### World Forum for Harmonization of Vehicle Regulations

### Working Party on Pollution and Energy

## Report of the Working Party on Pollution and Energy (GRPE) on its seventy-third session

**Flowchart MI trigger activation criteria**

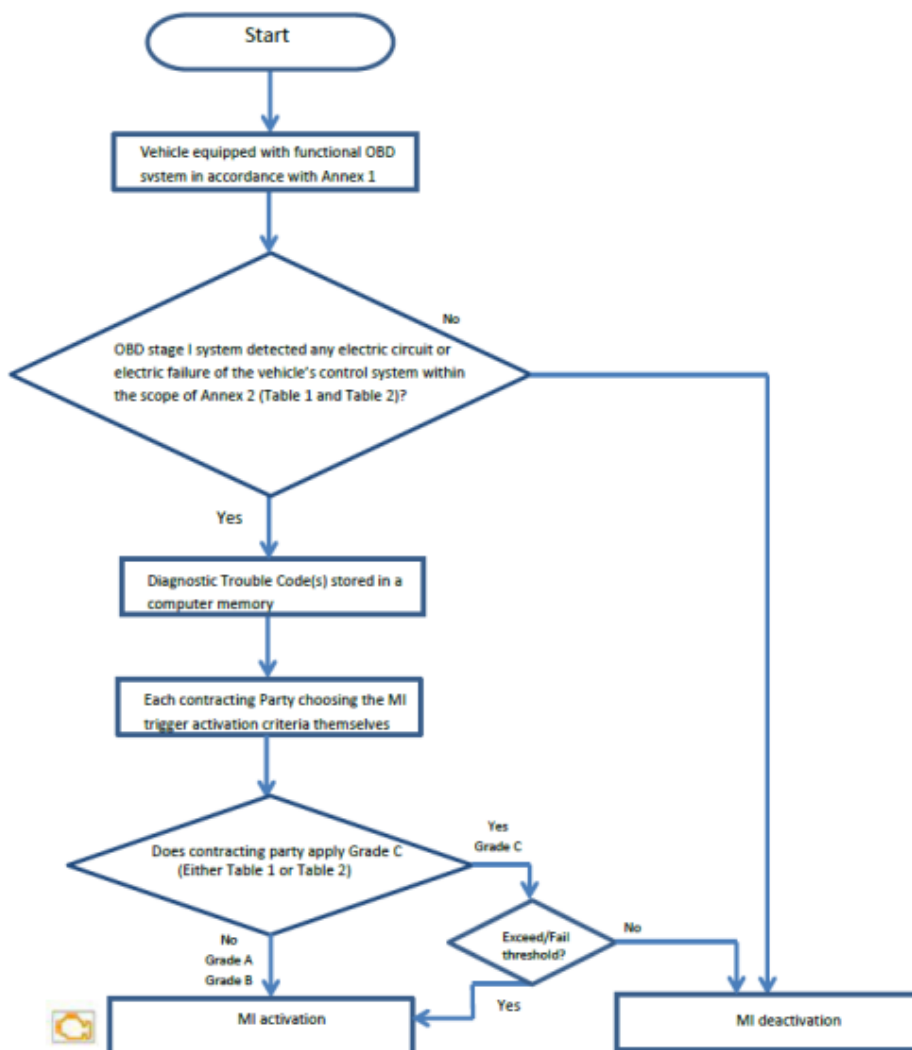
Paragraph 16., Figure 1, amend to read:
